REQUEST FOR INFORMATION	DATE: January 16, 2017	NO.: RFI-413
--------------------------------	-------------------------------	---------------------

Project Name: 15051-Webster University Interdisciplinary Science Building	Project No.: 15051
---	--------------------

Subject: Masonry base flashing detail

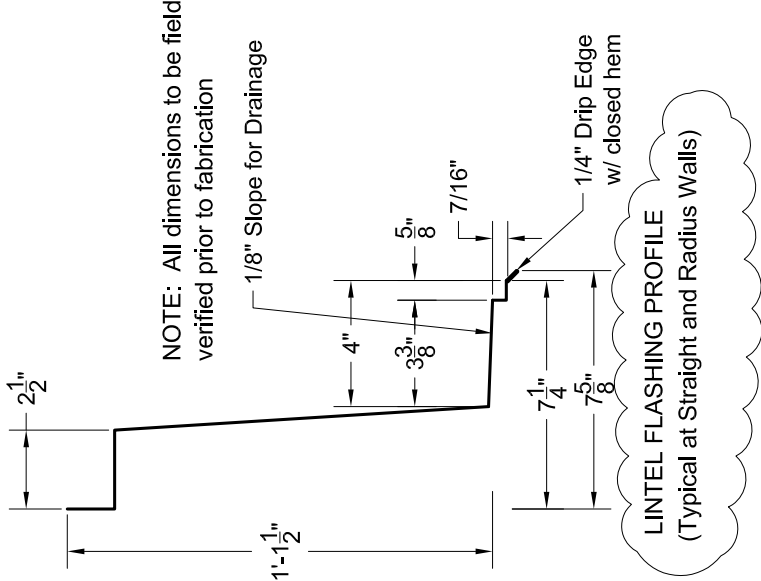
The approved base flashing profile as detailed cannot be fabricated for the radius brick wall. the manufacturer can produce it without the 1" chamfer at the bottom of the vertical leg. See attached drawing for revised detail. Please advise if this is acceptable.

Response: It is acceptable to eliminate the 1" chamfer at the radius brick thru-wall flashings. At flashing overlaps flashing should be overlapped 1" at the drip edge and the remaining drip edge below should be removed for the remainder of the flashing.
